**Technical Assistance Services for Communities**  
**Contract No.: EP-W-07-059**  
**TASC WA No.: R6-TASC-002**  
**Technical Directive No.: R6-Homestake Mining-02**

**Comments on Air Monitoring and Radon Issues Raised in the  
U.S. Army Corps of Engineers' Draft Remediation System Evaluation (Supplement)  
for the Homestake Mining Company (Grants) Superfund Site, New Mexico**

**May 6, 2010**

# Effluent Spray over EP1, April 2009

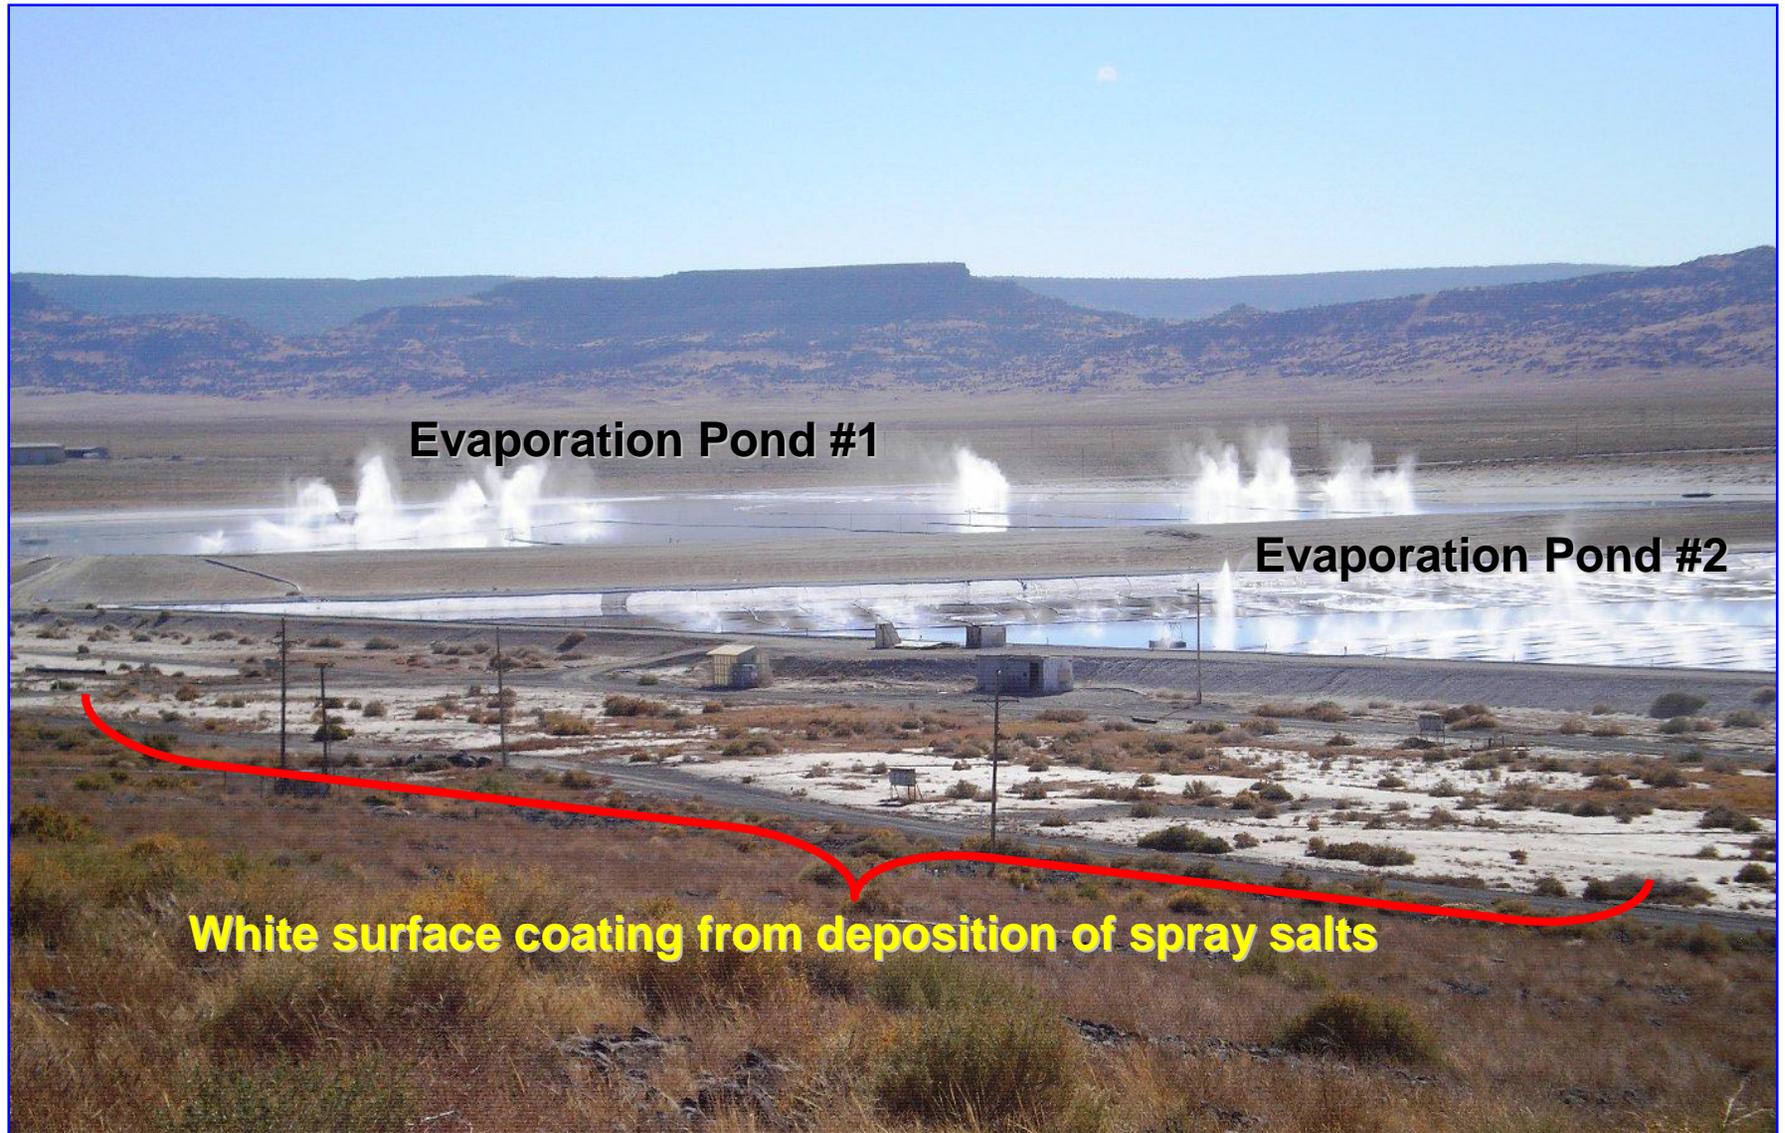
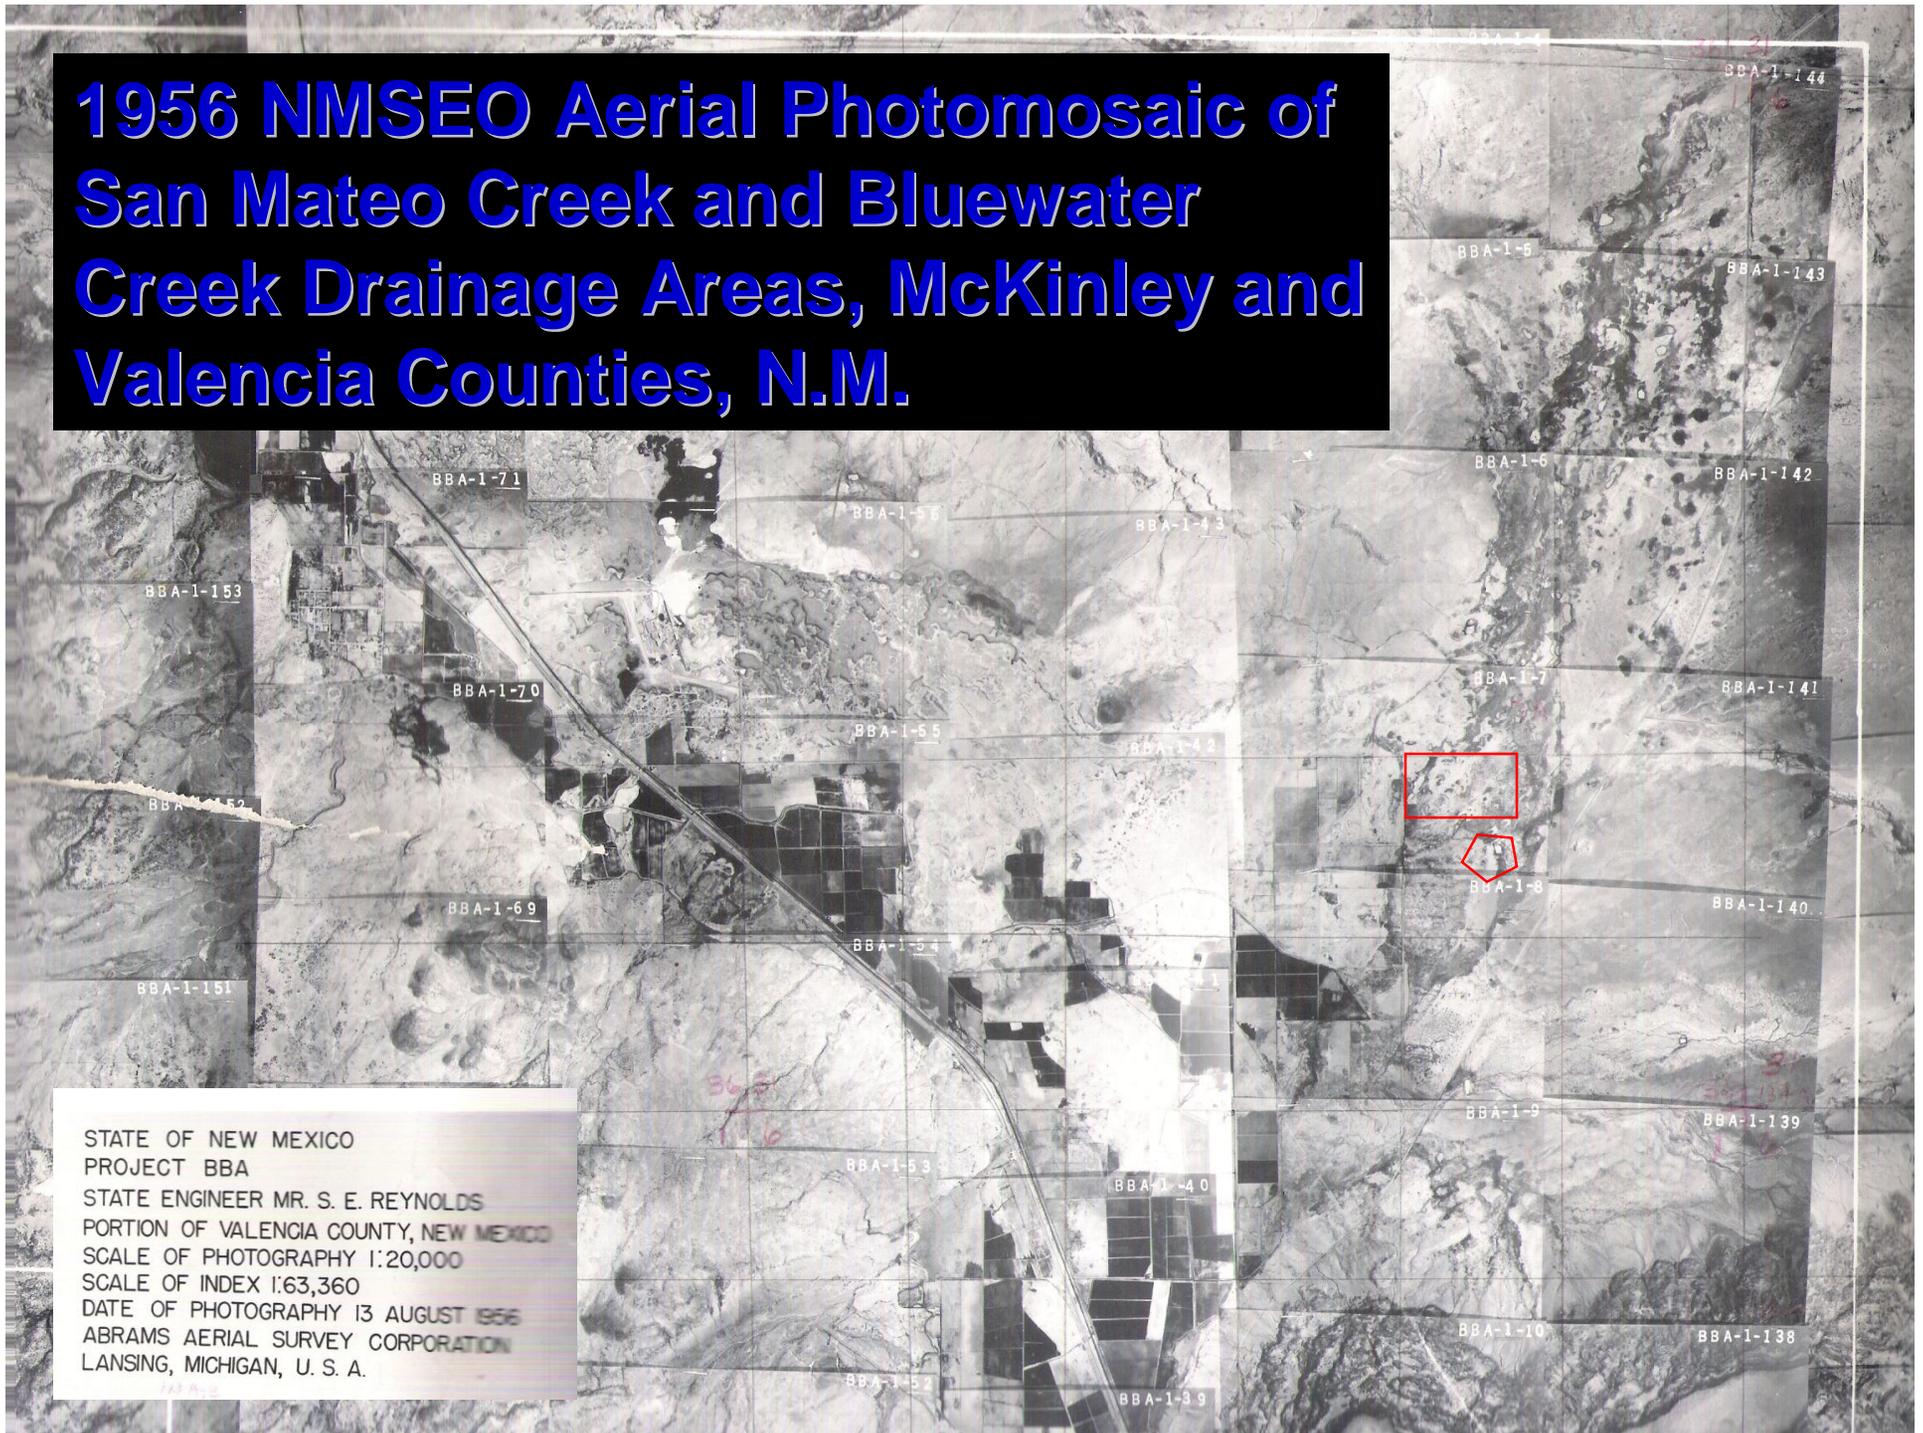
The TASC Report (p. 18) noted that local residents had reported in a letter to NMED in 2008 that sprays were being blown beyond the perimeter of the evaporation ponds. More recently, residents of the adjacent neighborhoods reported observing the effluent spray "drifting" into the community, and provided photographs to document their observations and concerns. (See, NMED Secretary, 2010; testimonies of Jonnie Head, pp. 291-292, Mark Head, pp. 294-295, and John Boomer, pp. 297-299.) The first RSE report concluded that the "completion elimination" of spraying "seems appropriate," given the reports of local residents and "the potential for human health and environmental exposure" (EQM, 2008, p. 48).

DP-725, issued as amended by NMED on April 12, 2010, is conditioned to require HMC to "operate the forced spray system such that the spray remains within the confines of the ponds to the extent practicable" (NMED, 2010, Condition 8, p. 6). The permit also requires HMC to submit to NMED a plan that outlines the specific atmospheric conditions, such as wind speeds and wind directions, under which the sprayers would not be operated or would automatically

(i) Homestake conduct and submit to NMED, NRC and EPA radiochemical analyses of precipitates deposited by the sprayers on the berms of the evaporation ponds as soon as possible.

(iii) DP-725 and SUA-1471 be amended to prohibit spraying when weather conditions would cause mists and precipitates to be deposited outside of the perimeters of the ponds.
